Intel[®] Ethernet Controller I210

Specification Update

Revision 2.4
332763-008

4. Flash Update Integrity Firmware Enhancements

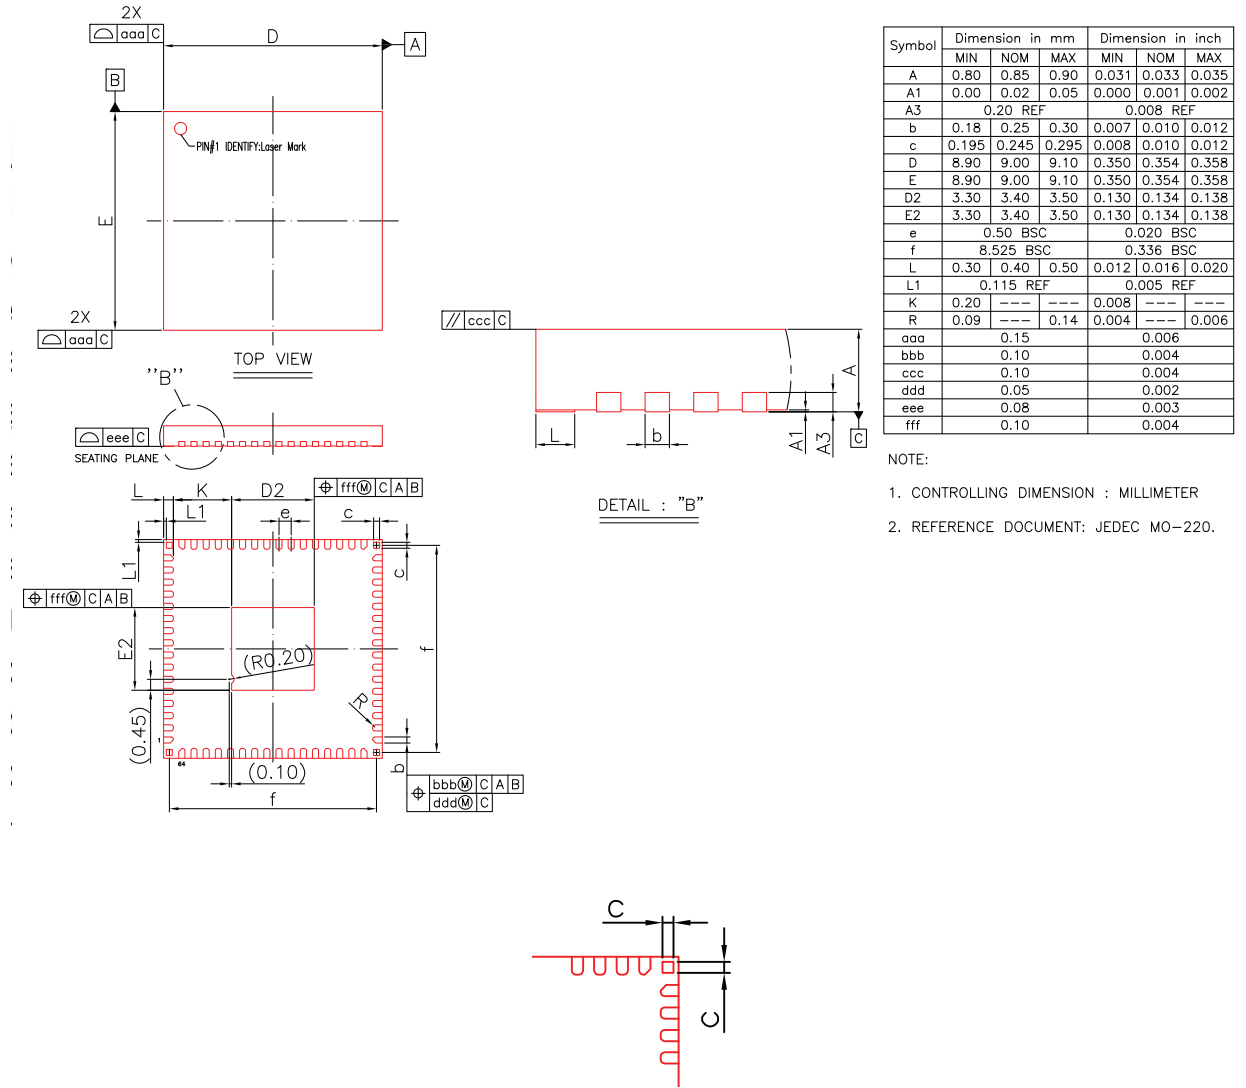
The I210 Flash Update integrity feature (Section 3.3.10 of the *Intel® Ethernet Controller I210 Datasheet*) ensures only Intel digitally signed updates can be applied to I210 products post manufacturing. This is achieved by a combination of hardware and firmware capabilities. NVM image release 3.20 includes firmware enhancements to improve the resilience of this feature.
